DART SERVICE INSTRUCTION

TO AMEND IIN-D412-704 REV. C OR EARLIER
AND ICA-D412-704 REV. 4 OR EARLIER

A	NEW ISSUE (REF PAR	RF	12.05.07
REV.	DESCRIPTION	BY	DATE
DESIGN	RF	DART AEROSPACE LTD	
DRAWN	RF	HAWKESBURY, ONTARIO, CANADA	
CHECKED	RF	DRAWING NO.	REV. A
MFG. APPR.	N/A	DSI 9611	SHEET 1 OF 2
APPROVED	RF	TITLE	SCALE
DE APPR.	RF	PART NUMBER CORRECTION	NTS
DATE	12.05.07	COPYRIGHT © 2012 BY DART AEROSPACE LTD THIS DOCUMENT IS PRIVATE AND CONFIDENTIAL AND IS SUPPLIED ON THE EXPRESS CONDITION THAT IT IS NOT TO BE USED FOR ANY PURPOSE OR COPIED OR COMMUNICATED TO ANY OTHER PERSON WITHOUT WRITTEN PERMISSION FROM DART AEROSPACE LTD.

Figure 5 - Detail L or Figure 25-4 - Detail L

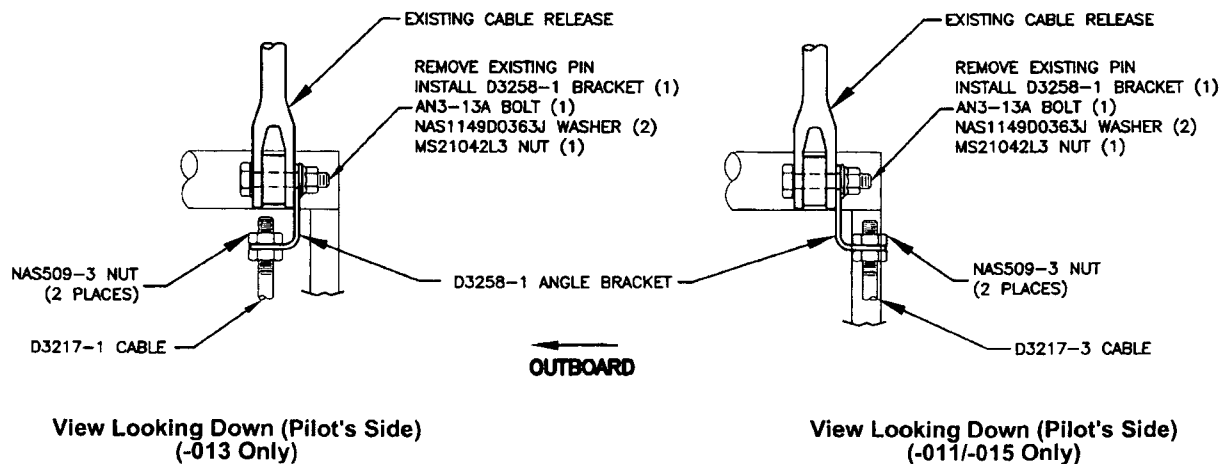
The purpose of this Dart Service Instruction is to correct part number error in Installations Instruction IIN-D412-704 Rev. C or earlier and Instructions for Continued Airworthiness ICA-D412-704 Rev. 4 or earlier. The AN3-13A bolt should be replaced with an AN3-10A bolt in Figure 5 - Detail L in IIN-D412-704 and Figure 25-4 Detail L in ICA-D412-704. See sheet 2.

FIGURES CORRECTION

Revise Detail L Figure 5 of IIN-D412-704 and Detail L Figure 25-4 of ICA-D412-704 as follows:

Qty -043	Qty -045	Part Number	Description
X		D205-704-043	CABLE ASSEMBLY (205)
	X	D412-704-045	CABLE ASSEMBLY (210/212/214/412)
1	1	AN3-10A	BOLT
